# THE SCHOOL DISTRICT OF PHILADELPHIA SCHOOL REFORM COMMISSION

#### Addendum No. 04

Subject: Bid Questions for Phase 1 Site Improvements at Central High School

Location: Central High School

C1.32

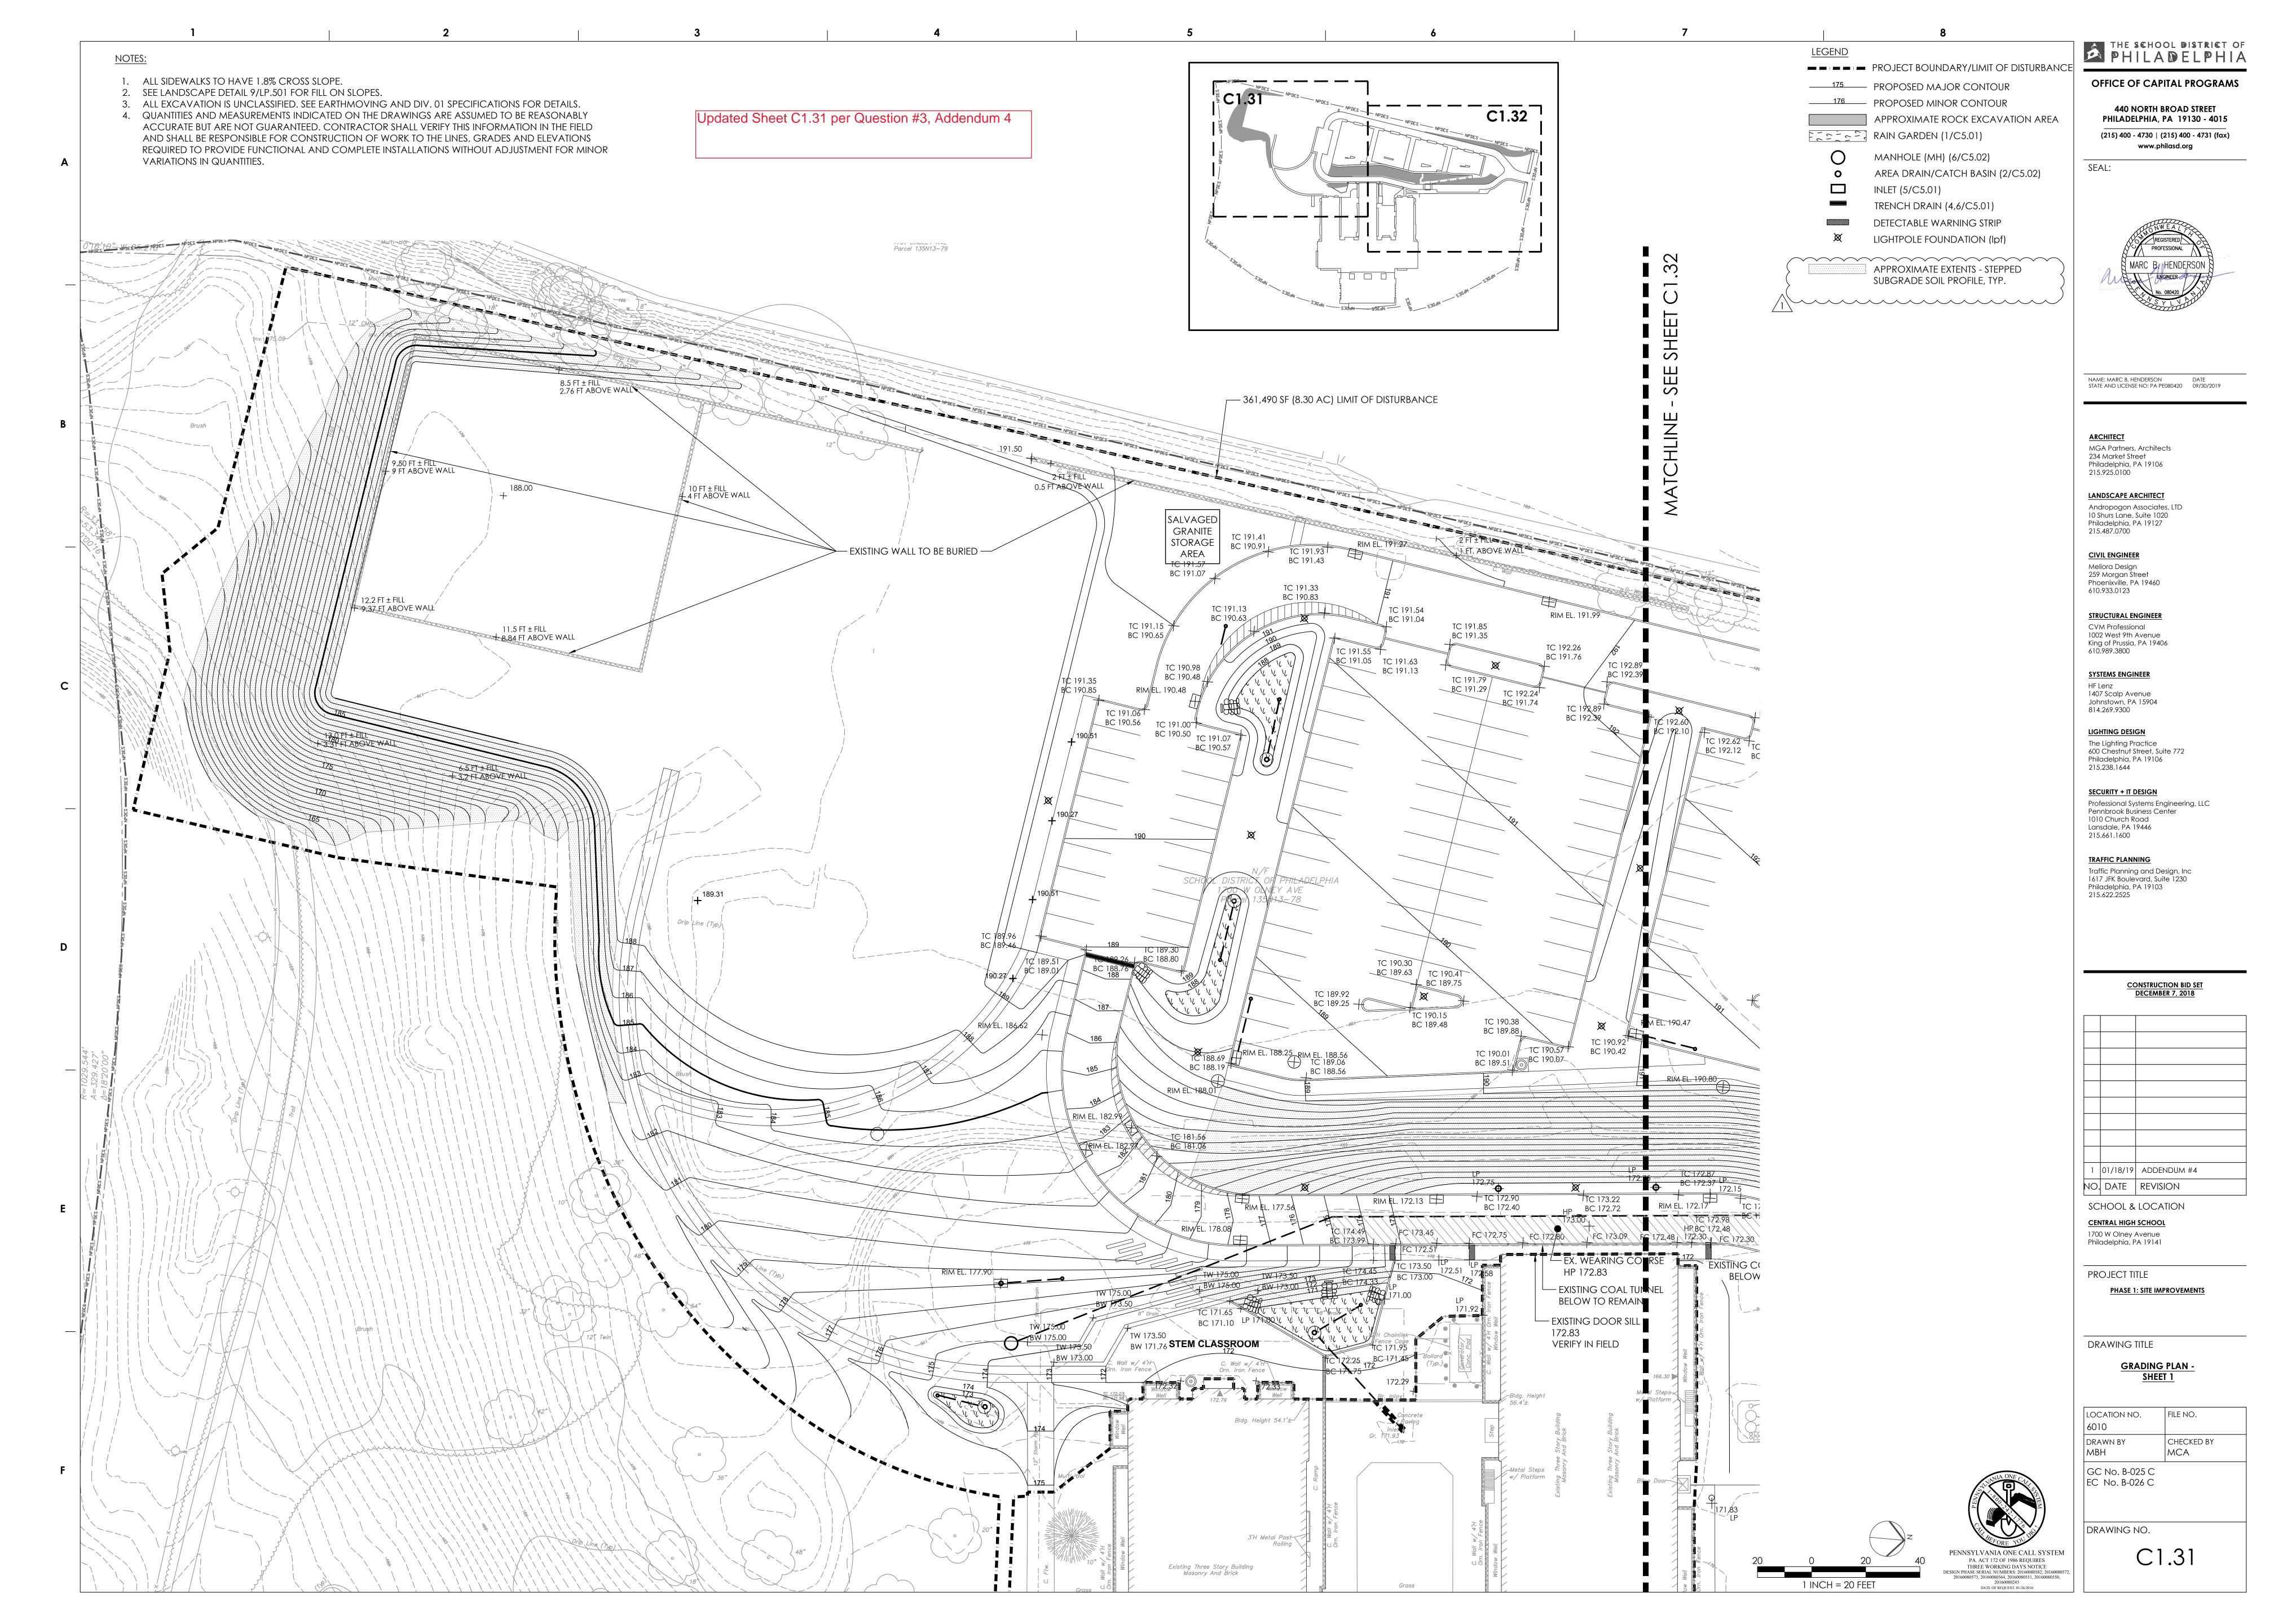
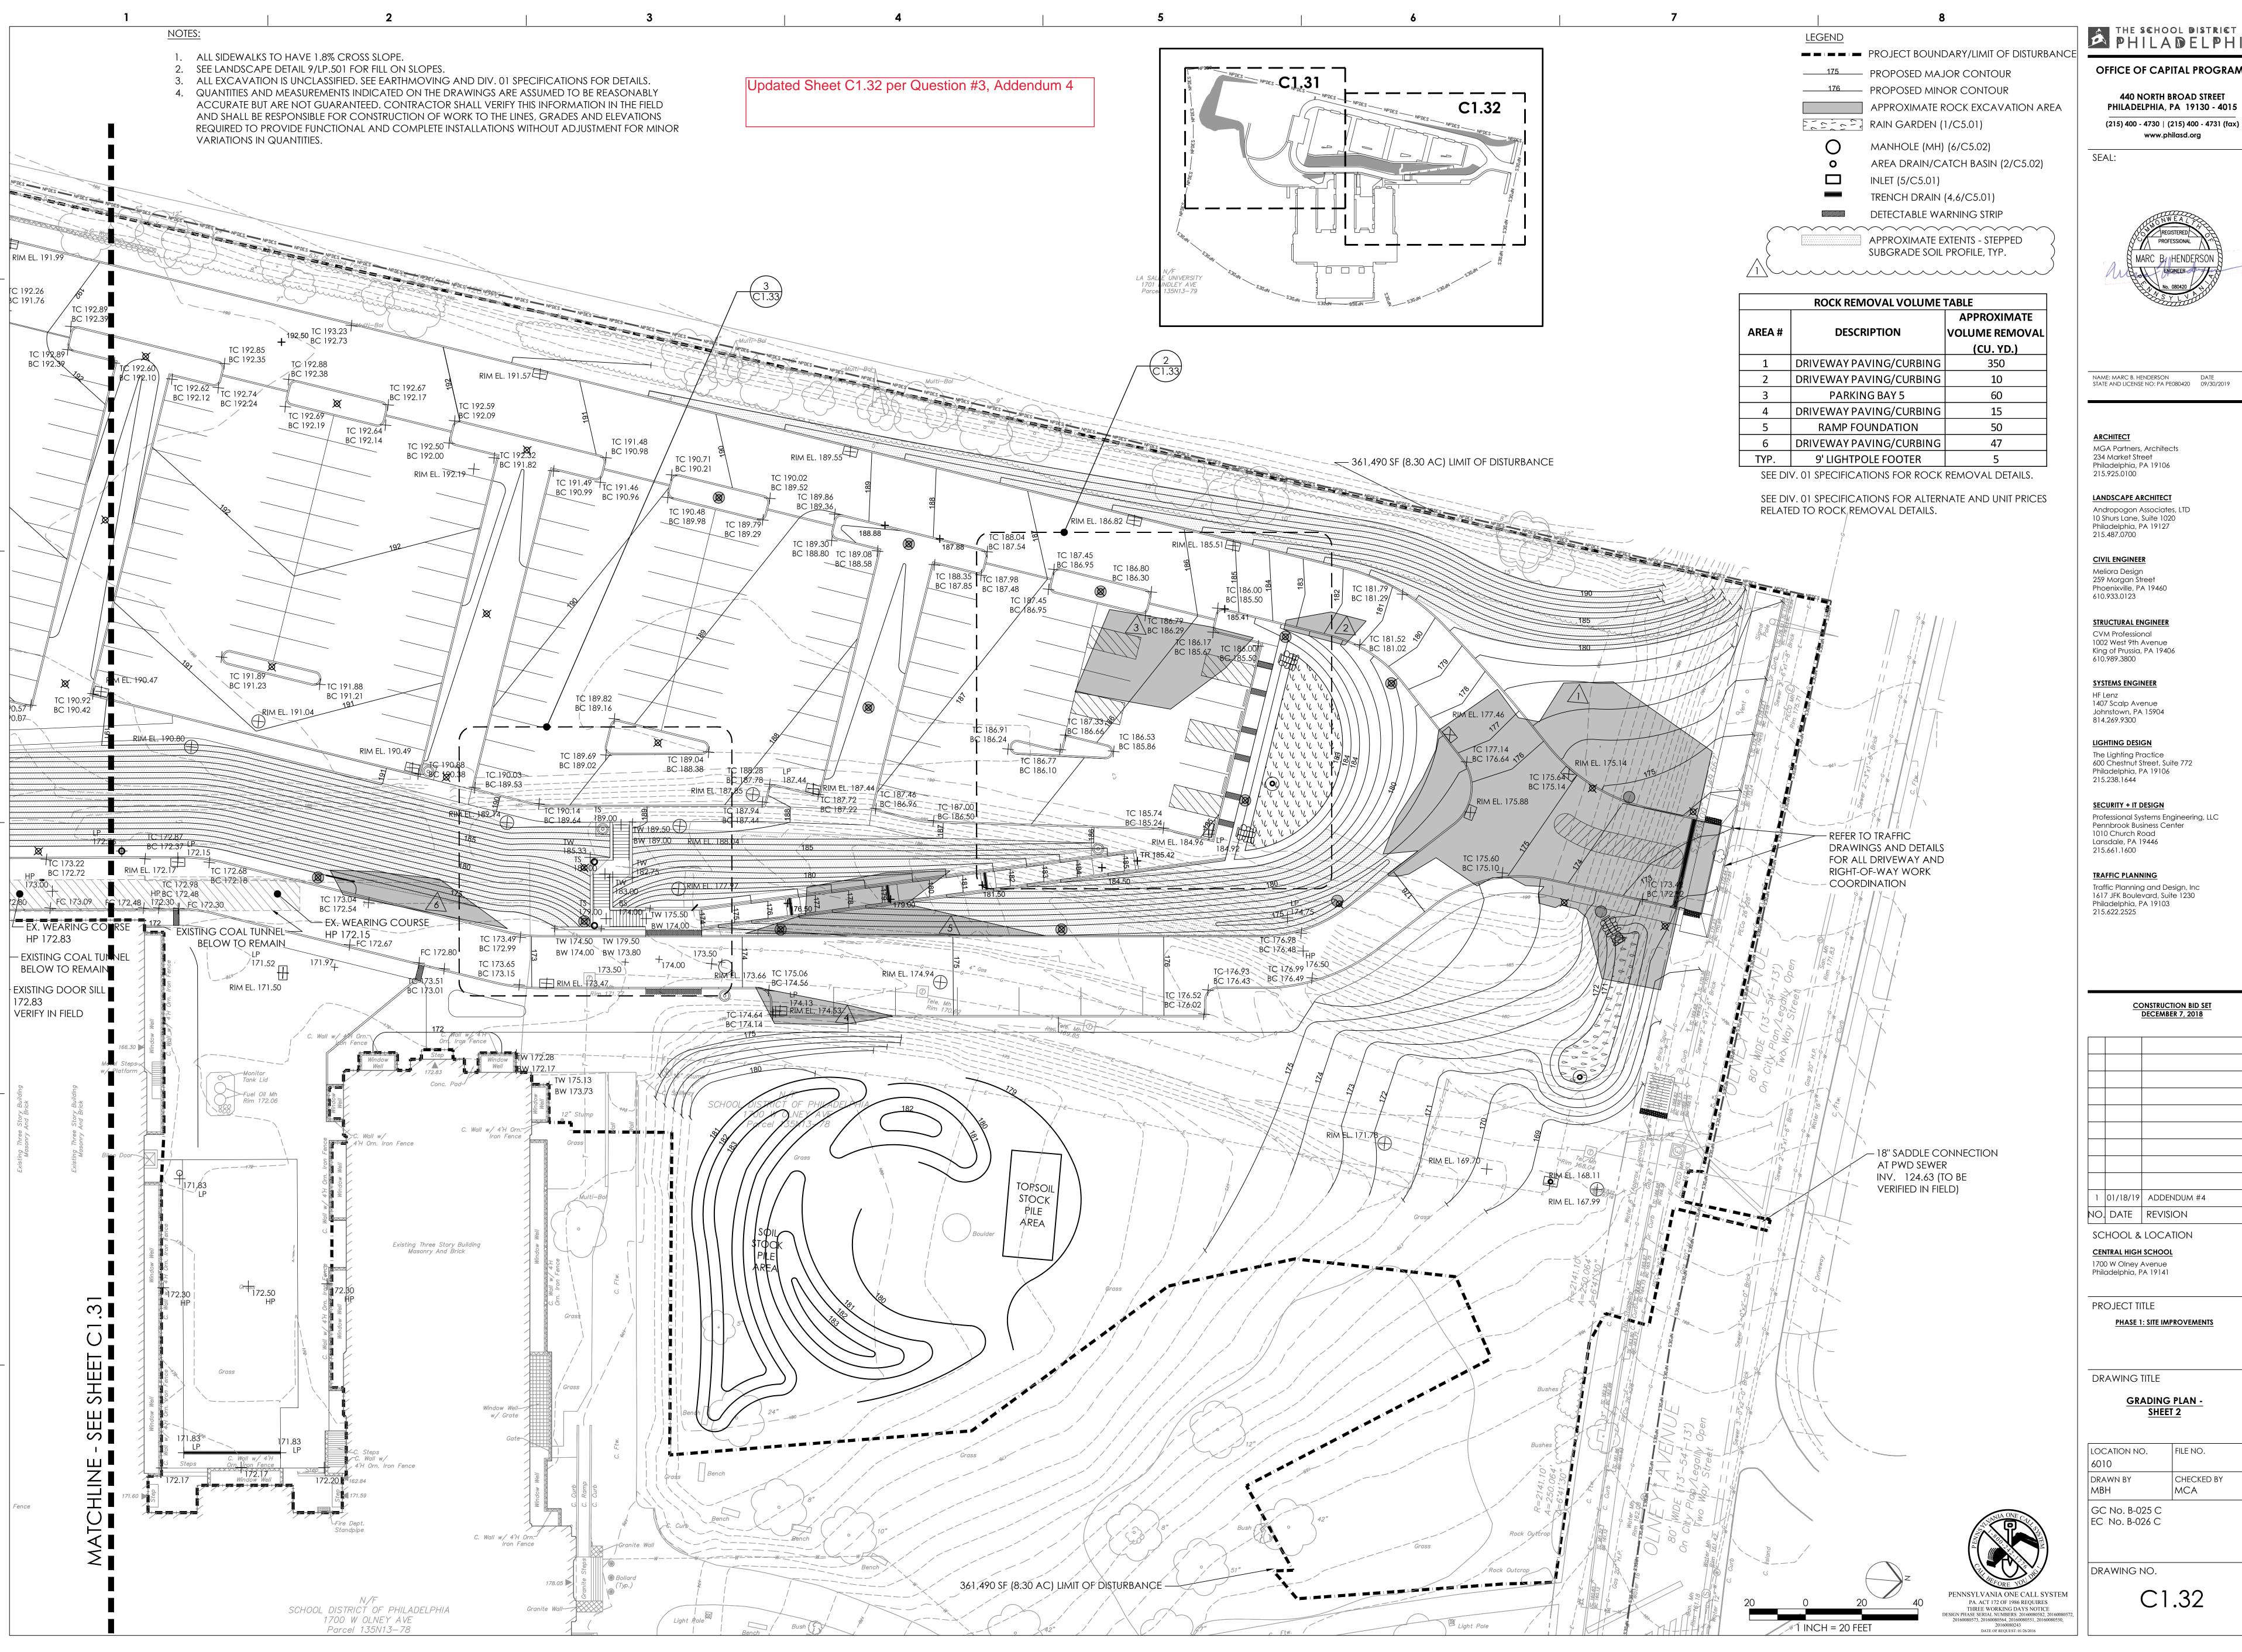
3. In regards to your tiered geo-fiber steps, can you us exactly where you want this done? What if I'm measuring a 1.9 to 1 slope on the plans and it's irregular in shape as to the grades above an area or below it, it doesn't make sense to just say everywhere 2:1 or greater, you should be telling us exactly where to do this so all bidders can measure the same thing accordingly. Each bidder will interpret this different from the next. Please consider something more practical like geocell.

**Response:** See revised sheets C1.31 and C1.32 for updated Grading Plans that include a hatch for slopes that require stepped subgrade soil profile.
